SUBJECT: Forwards annual const noise progress rept, "Sound Level Measurements Near Susquehanna Steam Electric Station Site Const 1980."

SUSQUEHANNA STEAM ELECTRIC STATION
CONSTRUCTION NOISE PROGRESS REPORT
ER 100450 FILE 991-2
PLA-837

SUBJECT: Study on Torsional effect on the seismic
response analysis of (1) ESSW Pumphouse
(2) Diesel Generator Building

FIGURE-1

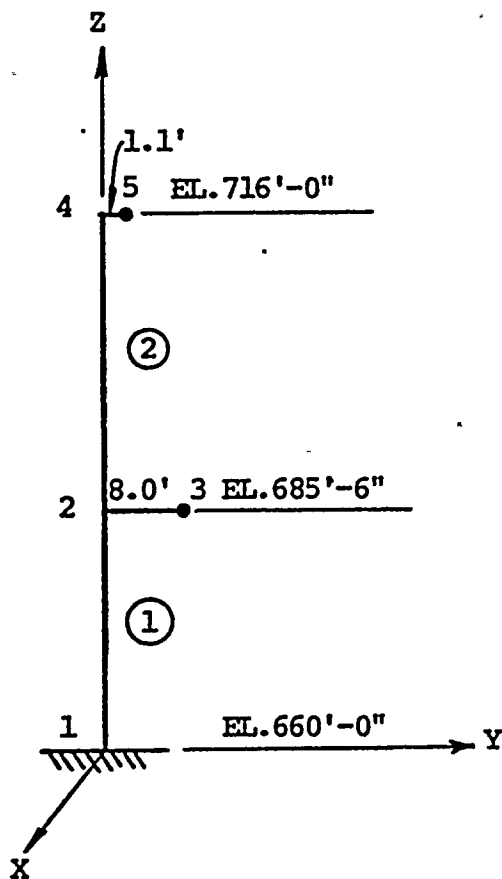
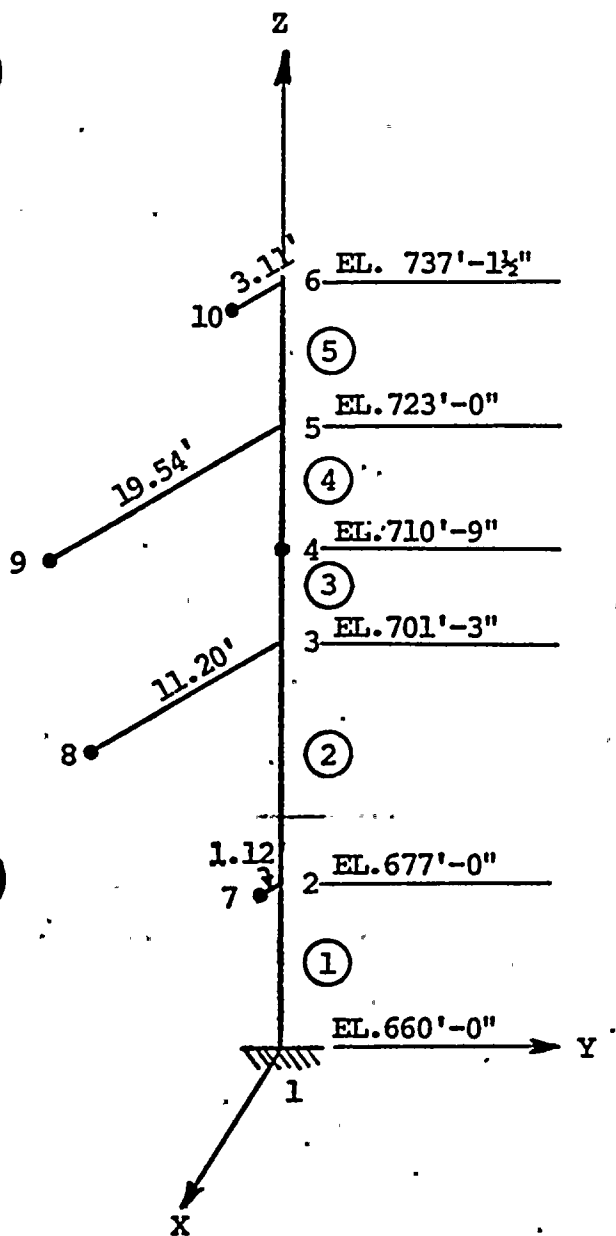
As requested by NRC analysis has been performed to study the effects of including torsion in the dynamic response analysis for (a) ESSW Pumphouse (b) Diesel Generator Building.

- (i) The eccentricities of these structures were calculated.
- (ii) The structures were represented by a fixed base 3-D stick models with structural masses properly lumped at the calculated eccentricities, as shown in Figure 1 and 2.
- (iii) Modal frequency analyses of the 3-D stick models were performed to determine the structure frequencies.
- (iv) The frequencies determined are then compared with the corresponding frequencies associated with the fixed base models having zero eccentricities.

TYPICAL WALL FIXES

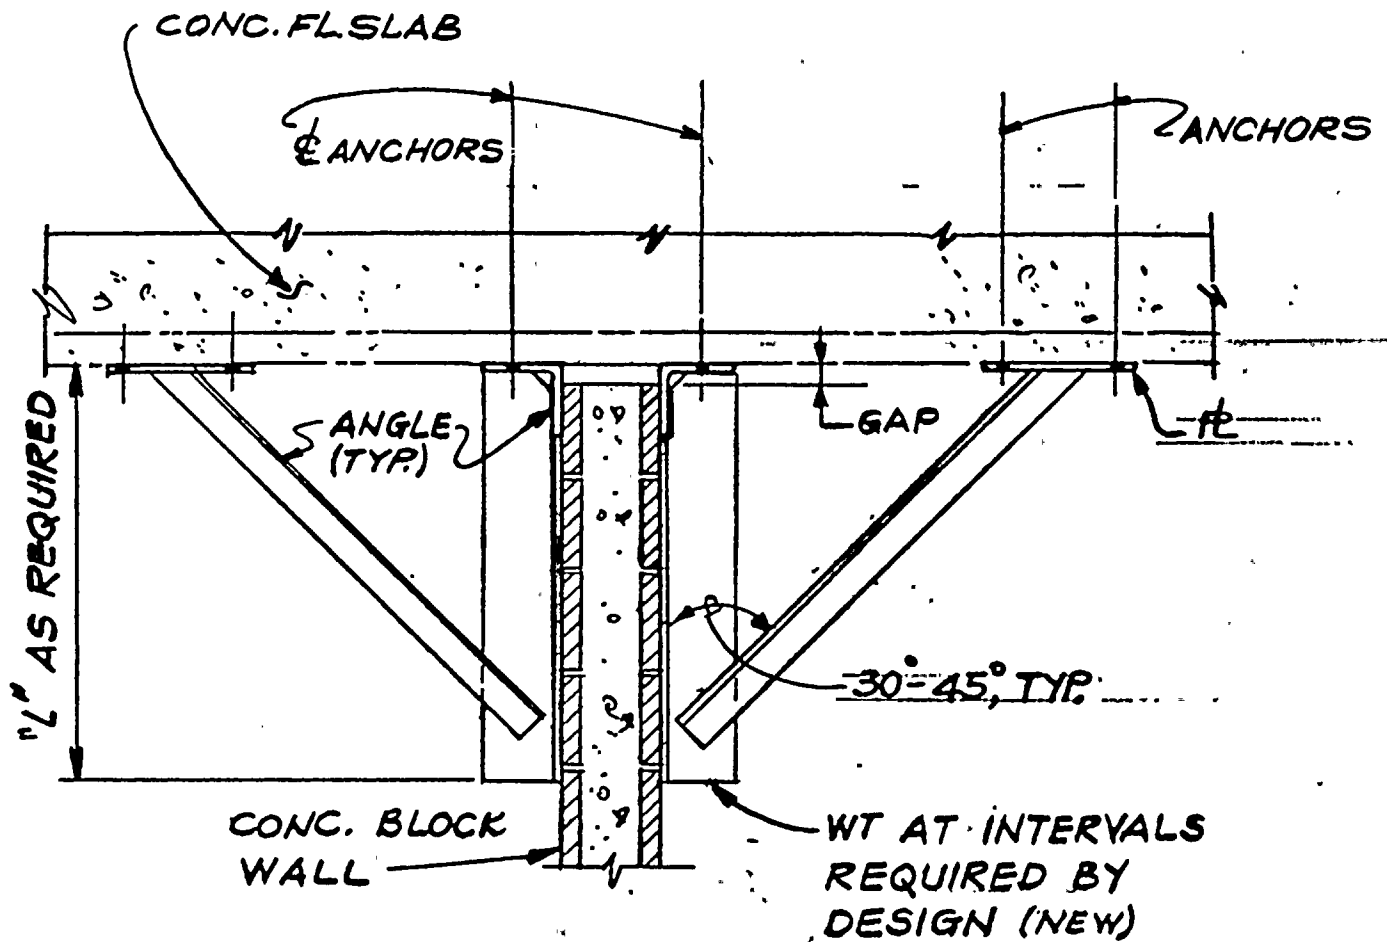
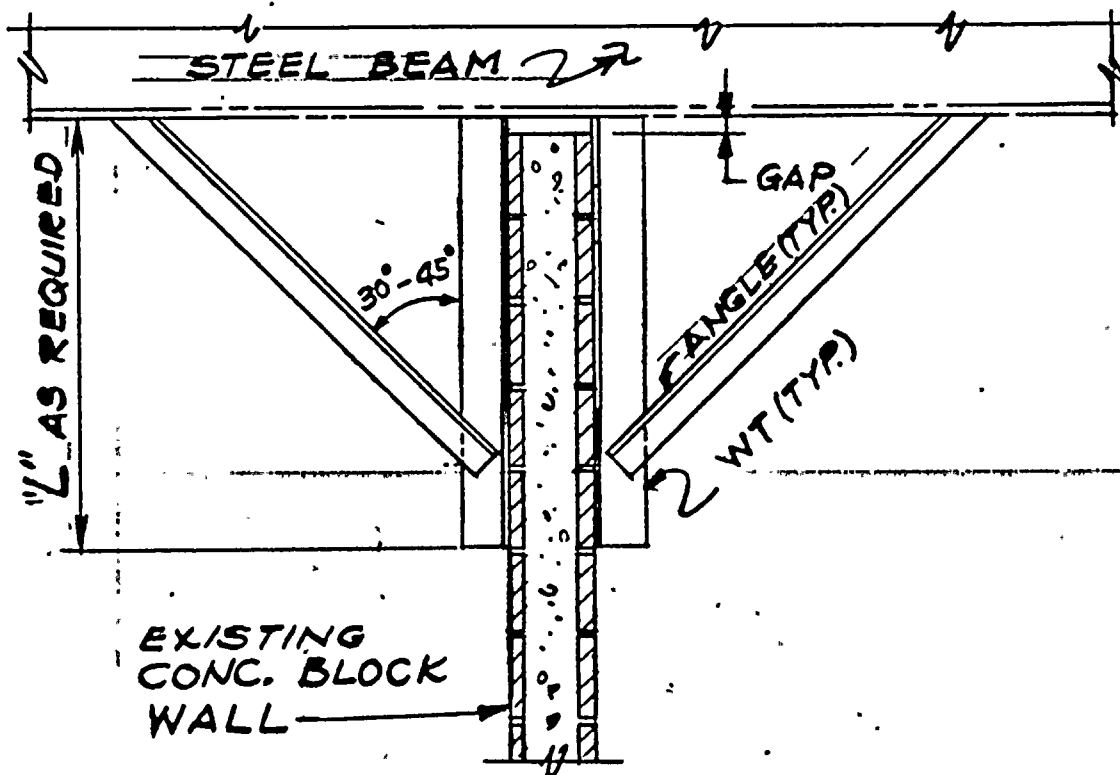
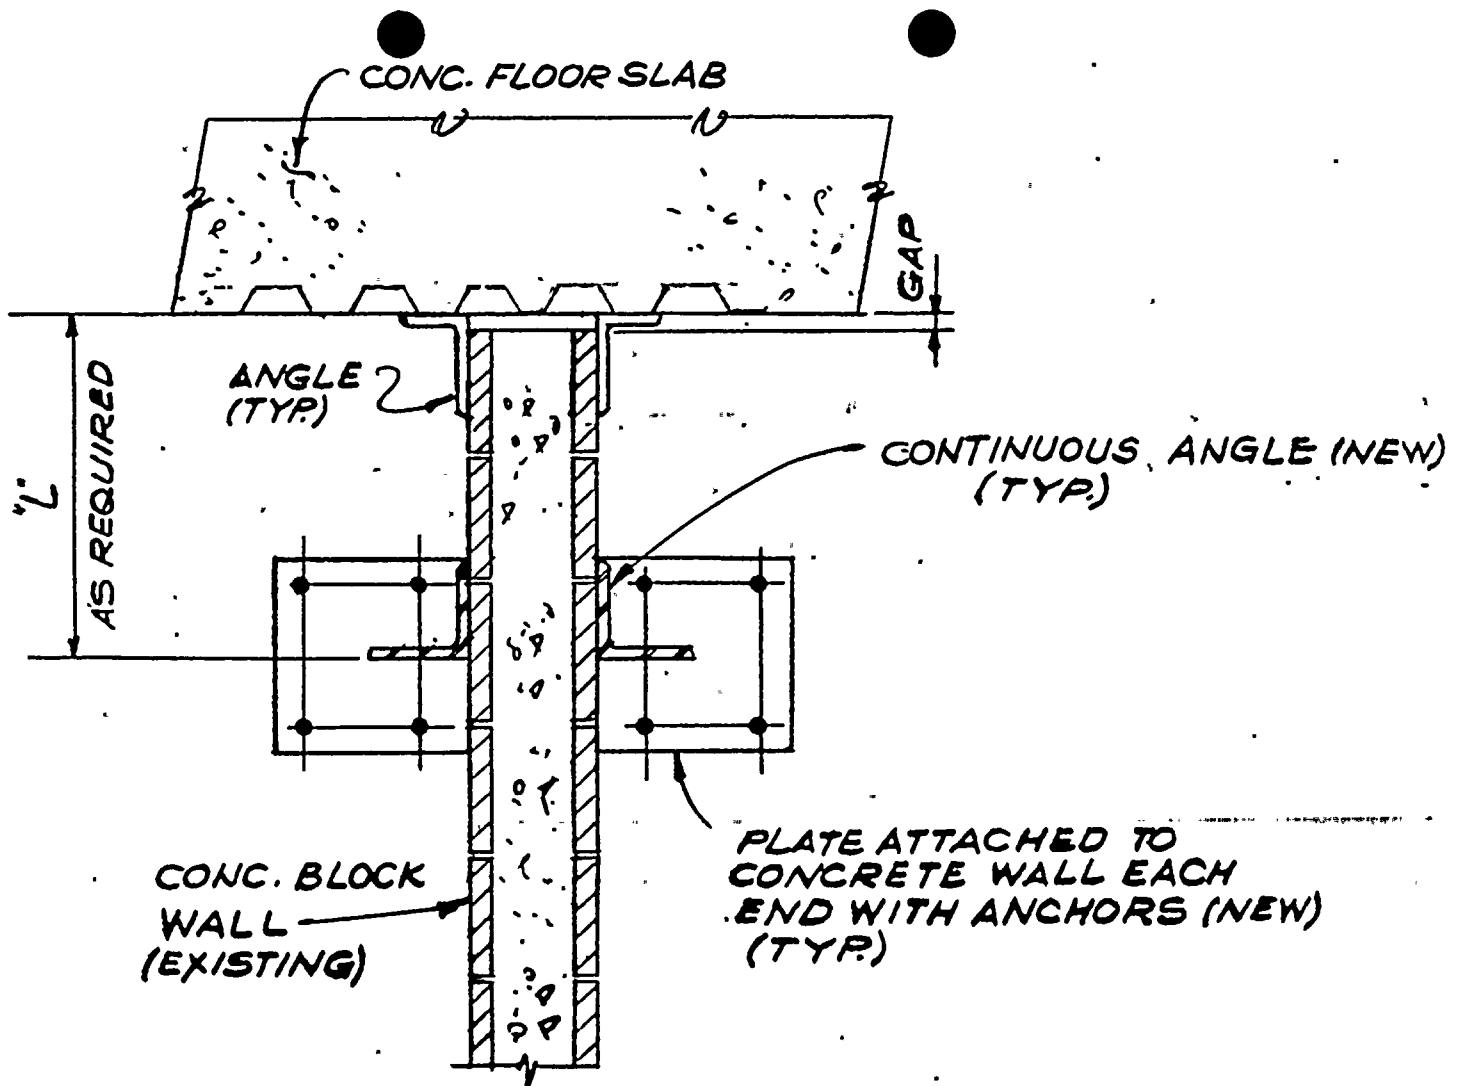
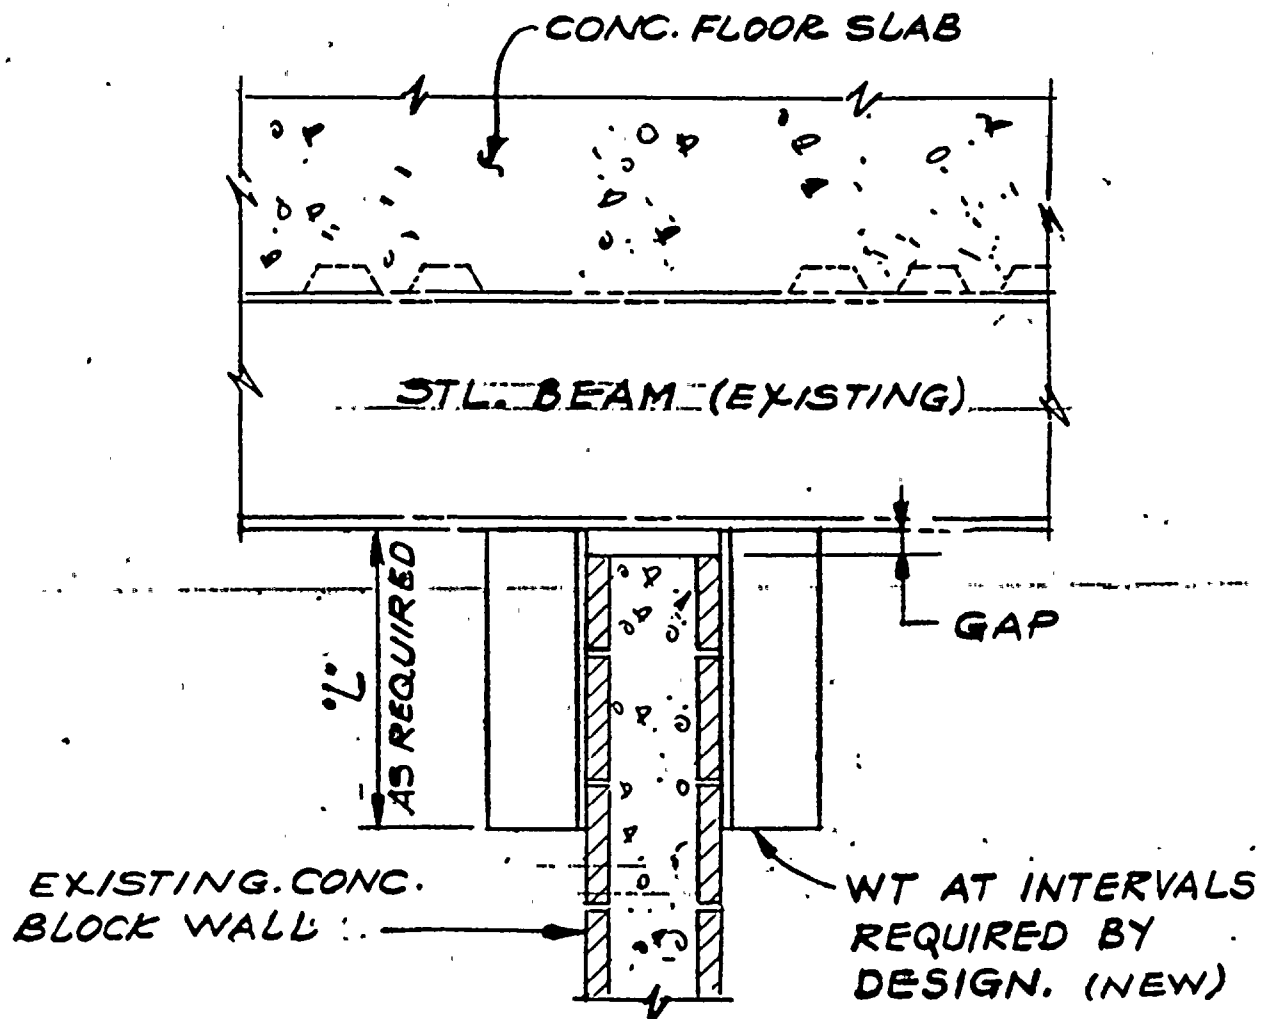
In response to Question 5, it is stated that when the design stresses of masonry walls exceed the allowable stresses, fixes are designed such that the criteria is satisfied. Indicate the number of walls where such fixes are needed and provide examples.

RESPONSE:

FIGURE-1

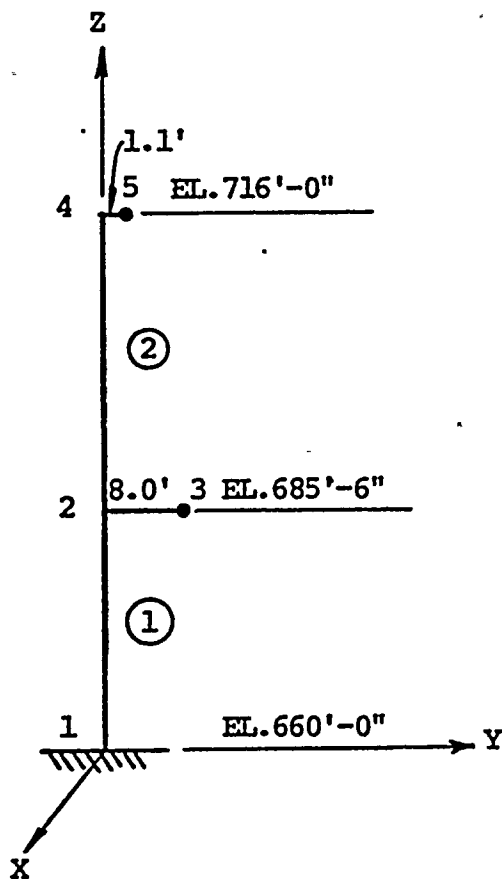
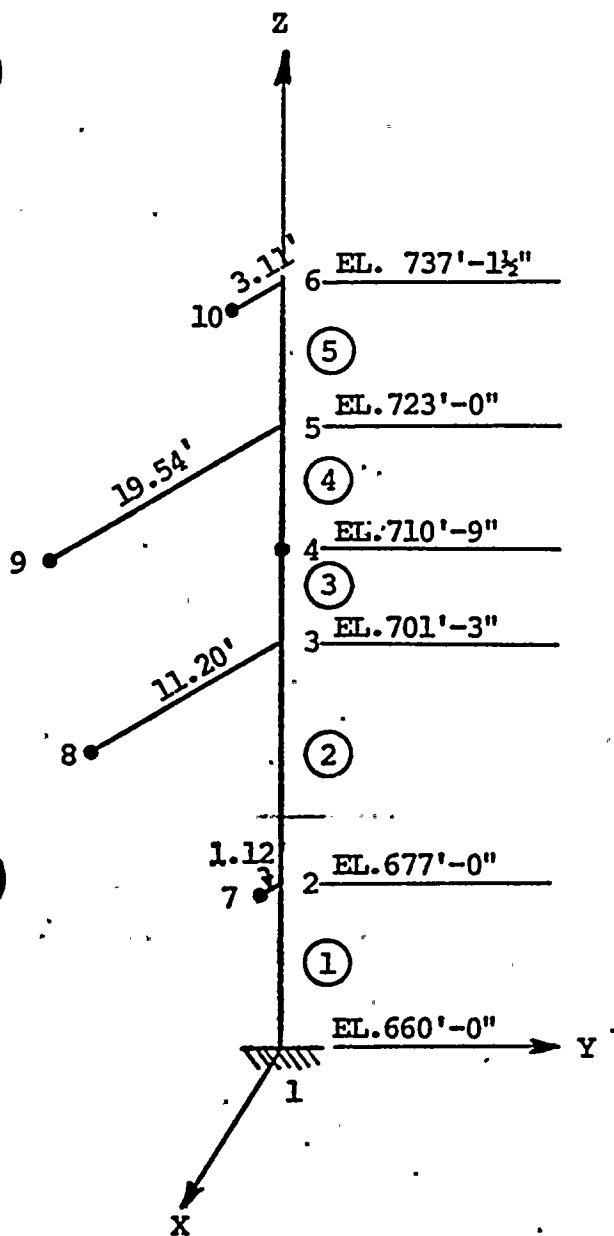
As requested by NRC analysis has been performed to study the effects of including torsion in the dynamic response analysis for (a) ESSW Pumphouse (b) Diesel Generator Building.

- (i) The eccentricities of these structures were calculated.
- (ii) The structures were represented by a fixed base 3-D stick models with structural masses properly lumped at the calculated eccentricities, as shown in Figure 1 and 2.
- (iii) Modal frequency analyses of the 3-D stick models were performed to determine the structure frequencies.
- (iv) The frequencies determined are then compared with the corresponding frequencies associated with the fixed base models having zero eccentricities.
